STAFF RECOMMENDATION
111 4th Avenue South
April 19, 2017

Application: Partial demolition; New construction—addition
District: Broadway Historic Preservation Zoning Overlay
Council District: 19
Map and Parcel Number: 09306400800
Applicant: John TeSelle, Architect
Project Lead: Sean Alexander, sean.alexander@nashville.gov

<p>Description of Project: An application to enlarge a two-story building by constructing a partially enclosed third story with an uncovered roof deck, and to extend an existing stair tower to the new third floor.</p>	<p>Attachments A: Photographs B: Site Plan C: Elevations</p>
<p>Recommendation Summary: Staff recommends disapproval of the proposed rooftop addition, finding that the request does not meet the design guidelines for rehabilitation (II.L.), additions (III.H.3) or demolition (V.1).</p>

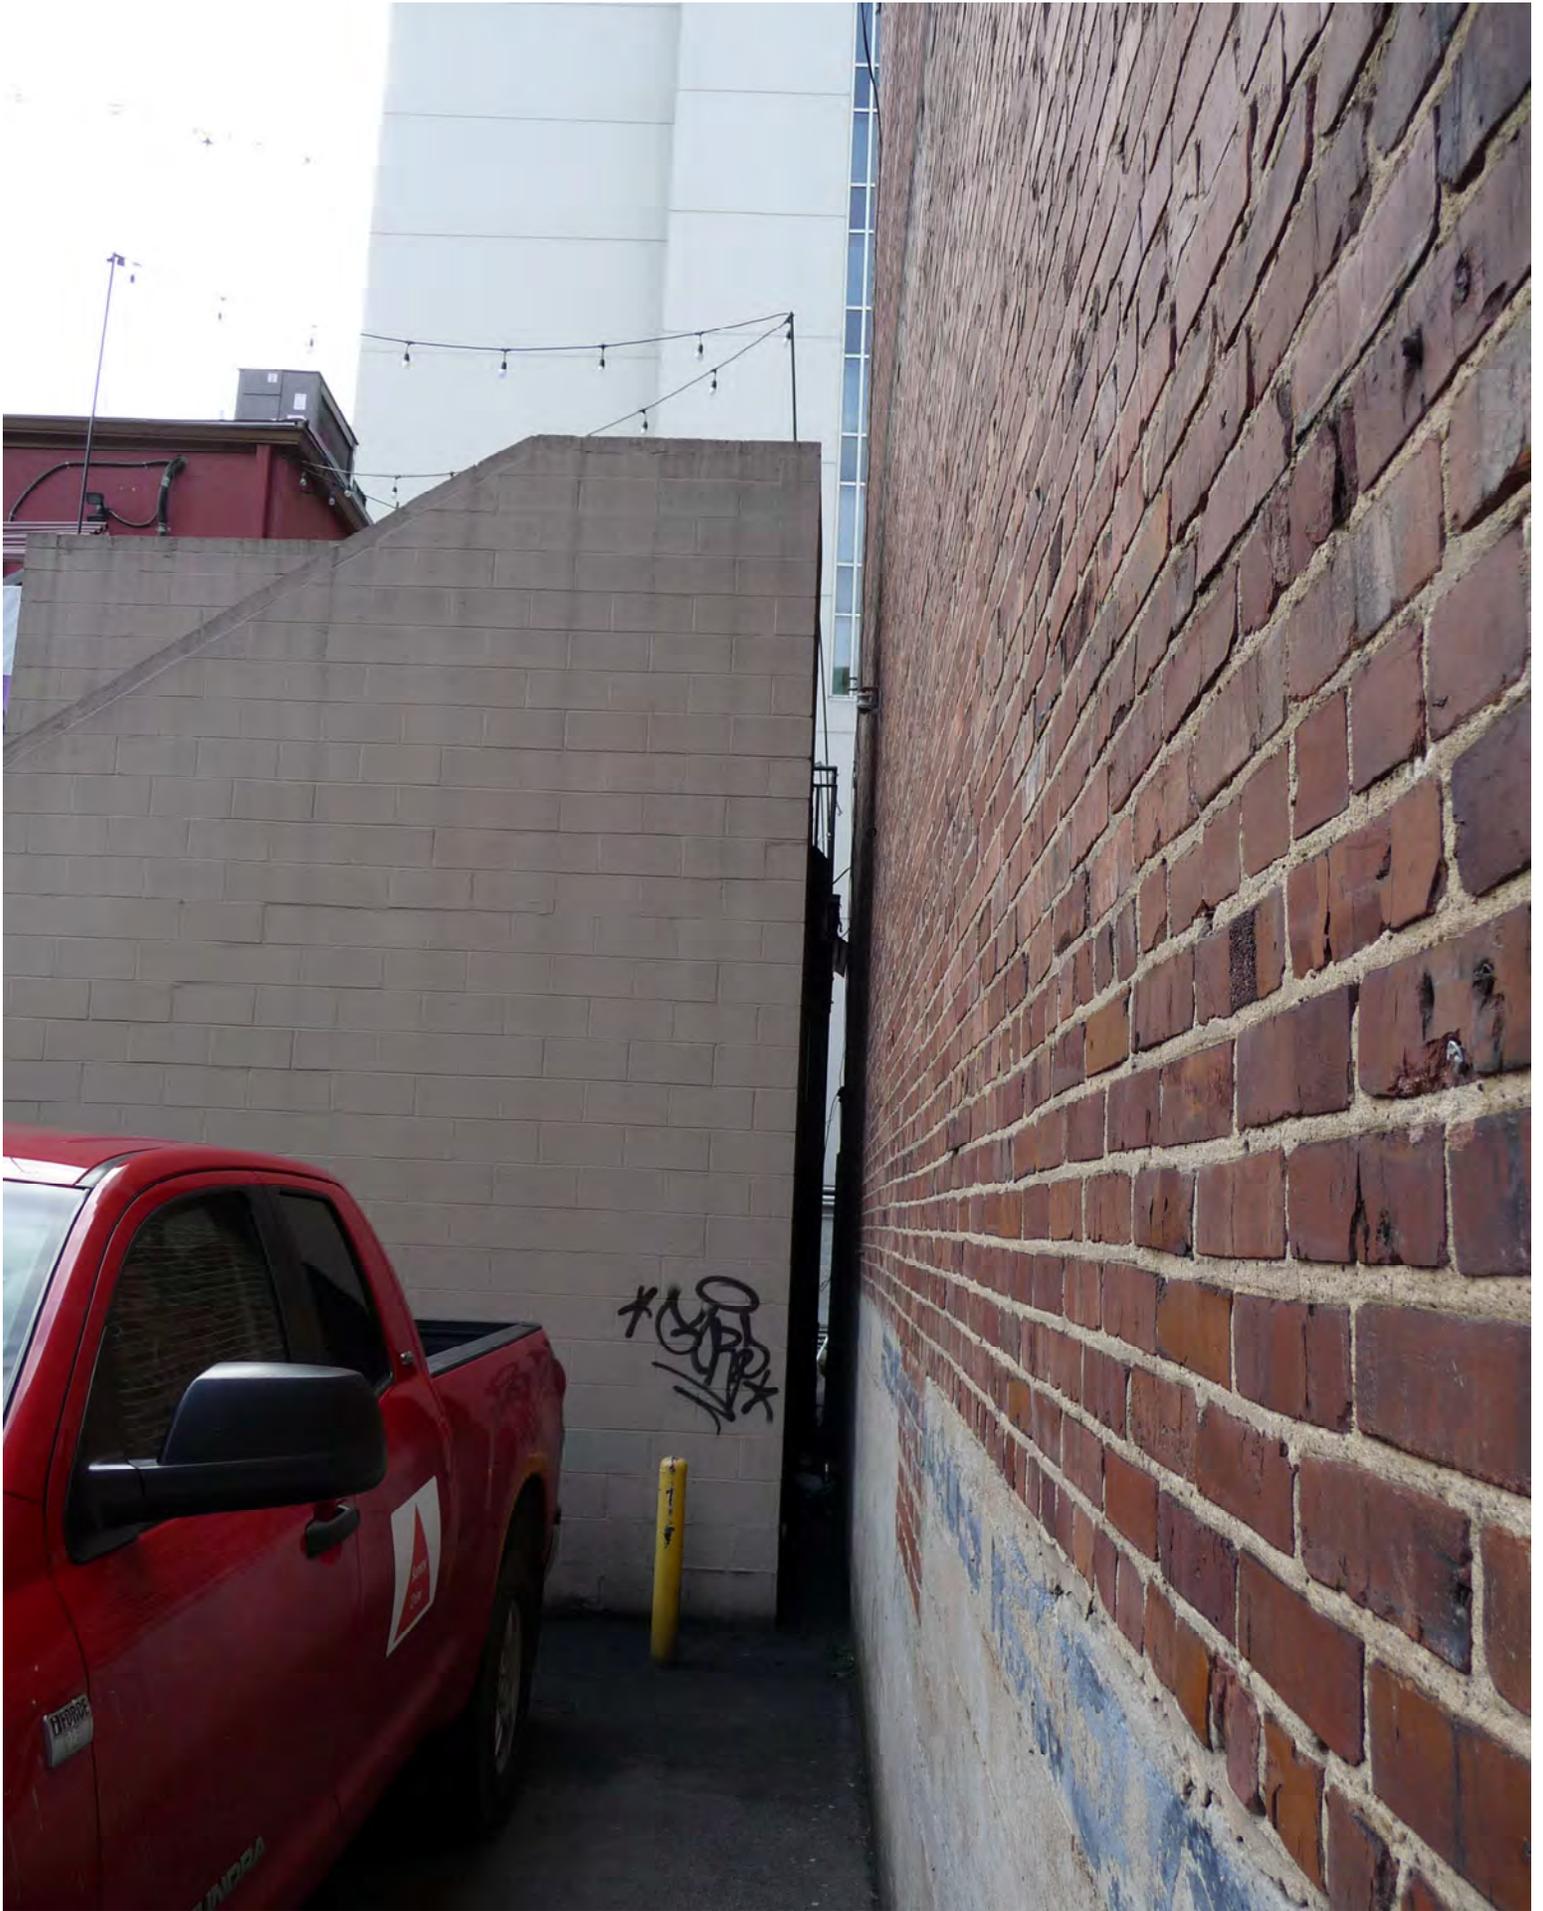
Demolition: Construction of the addition and deck would require the demolition of the original hipped roof and four chimneys. The hipped roof on this building is a rare architectural feature in the in the Broadway Historic District as the majority of buildings have flats roofs. Staff finds that the removal of the roof and all the chimneys is not appropriate under section V.1 the design guidelines for the Historic Preservation Zoning Overlay. The removal also does not meet section III.H.3 for additions which states that “additions should not obscure or contribute to the loss of historic character-defining features or materials” and section II.L.1 which states that “historic roofs, chimneys, and related elements should be retained.”

It may be appropriate to remove the roof and chimneys on roughly the rear third of the building to accommodate an addition, leaving approximately the front two-thirds of the historic roof form intact; however, the applicant wished to bring the current proposal to the Commission. (Staff has not explored other alternatives in great detail since the applicant wished to move forward with the current application.)

Existing chimney proposed for removal due to construction of rooftop addition

Existing chimney proposed for removal -- to be covered by new rooftop addition

Existing chimney proposed for removal (deck railing area)

Existing metal covered chimney proposed for removal

Hipped roof proposed for removal to construct addition and rooftop deck

Chimney proposed for removal (in area of new addition)

ROOF DEMOLITION PLAN

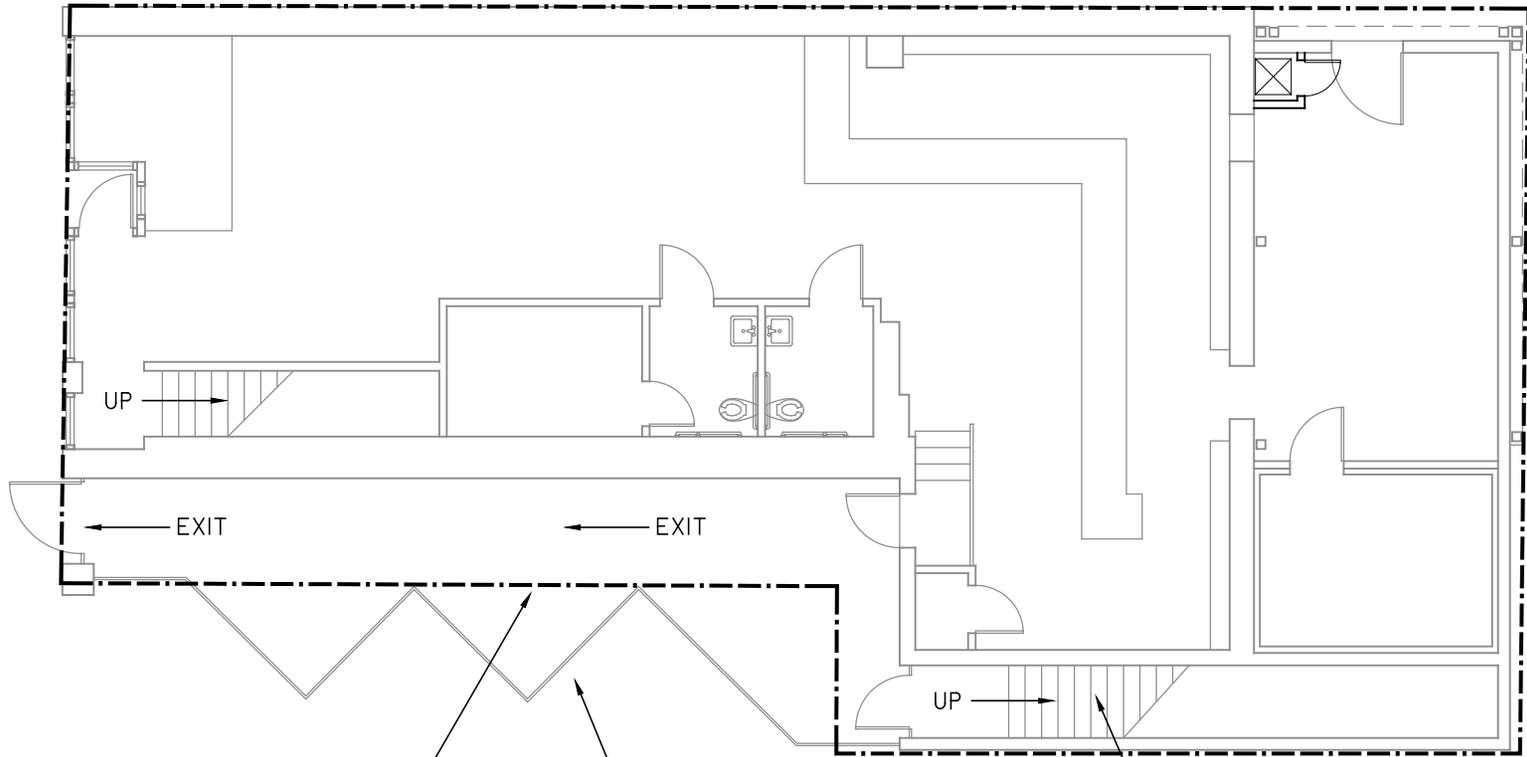
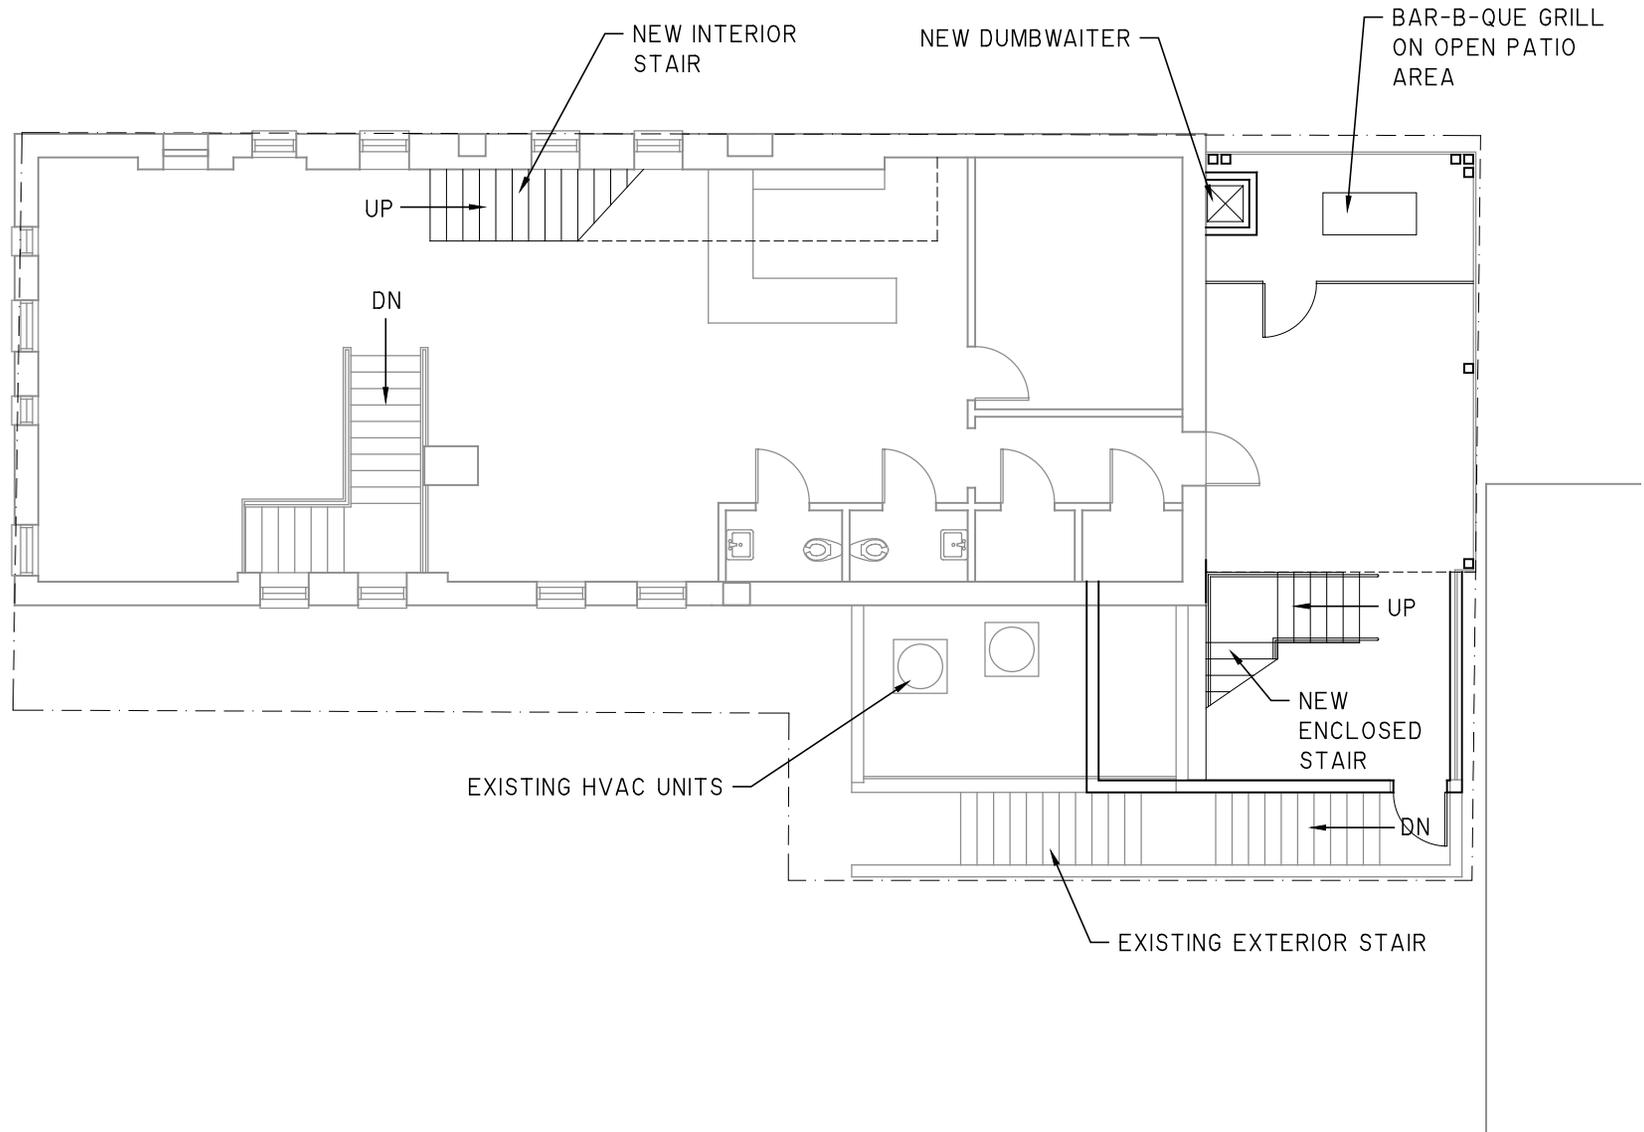
Because the historic roof form would need to be removed, the roof is not an appropriate location for an addition. The existing non-historic left side stairs will be extended to the second and new third story. The stair tower will be ten feet (10') wide. The stair

structure will be enclosed, beginning sixty-feet (60') back from the front of the building. Side additions are generally not possible as most buildings in the district span the entirety of their respective lots, however because of the odd shape of this lot and the presence of the existing exterior stair, Staff finds the proposed stair tower addition to be appropriate.

NORTH ELEVATION
 0 2' 4' 8' 16' 32'

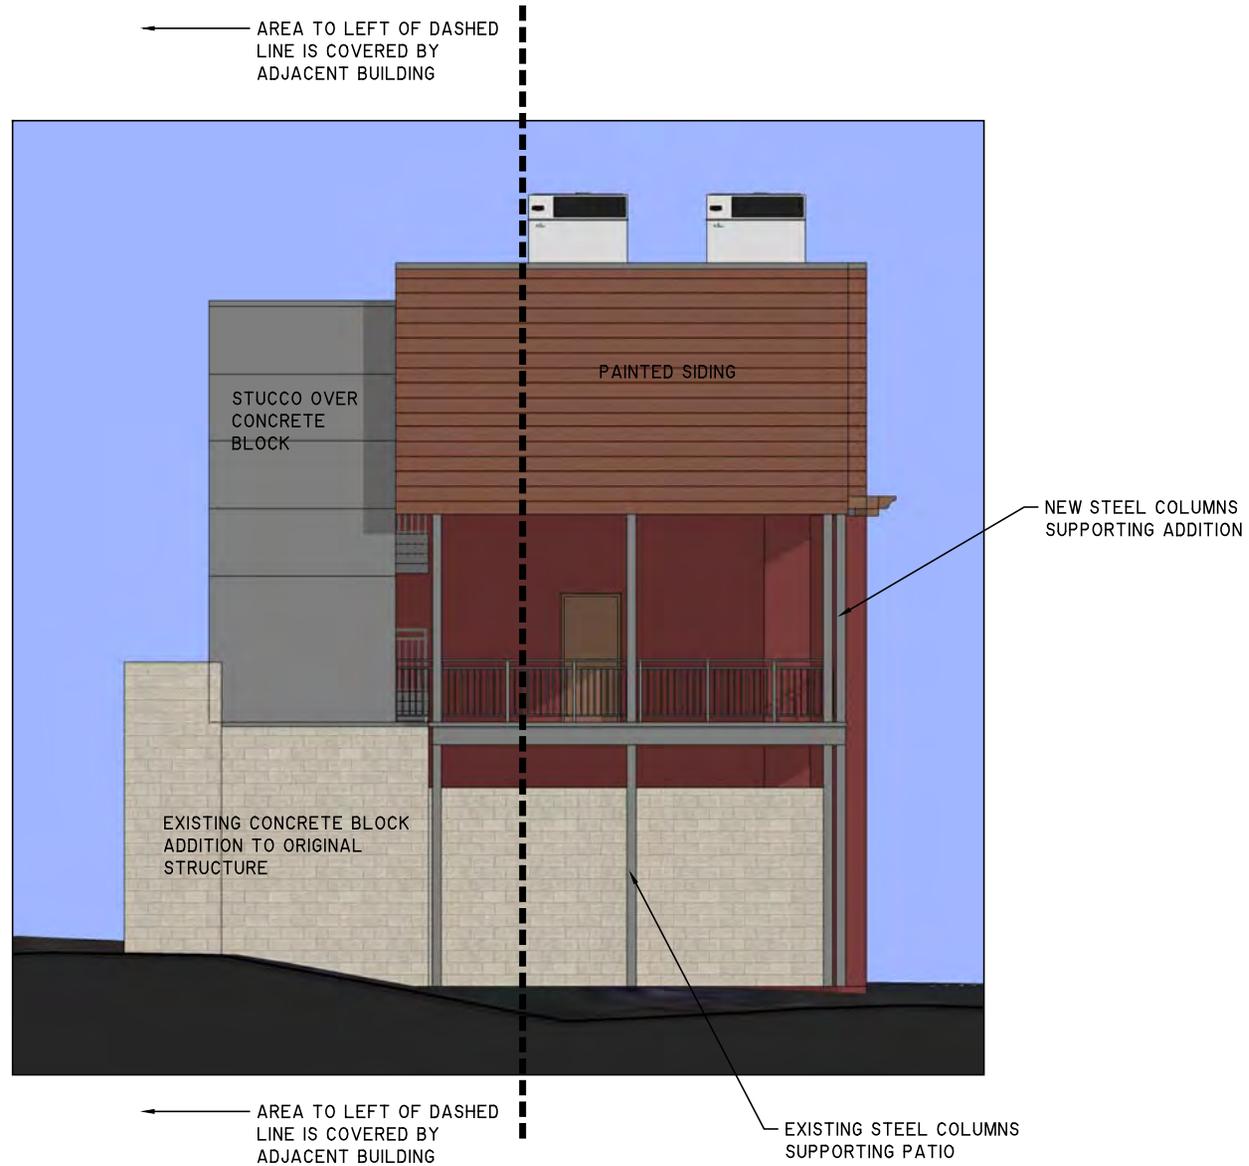
Height: The design guidelines require that a rooftop addition be no taller than fifteen feet (15') above the front parapet wall. The proposed side addition would be thirteen feet (13') tall, which is appropriate. The height of the rooftop portion of the addition is not relevant since it is not in an appropriate location and would require the removal of a historic feature. Staff finds that the height of the addition does not meet section III.H.2 of the design guidelines.

Materials: The addition's materials include painted wood siding with aluminum storefront type windows and a garage-type door on the front wall. The addition to the enclosed stair towers would have a stucco exterior. The front roof deck ailing would be aluminum with steel cable rails. Additional information is needed regarding materials.
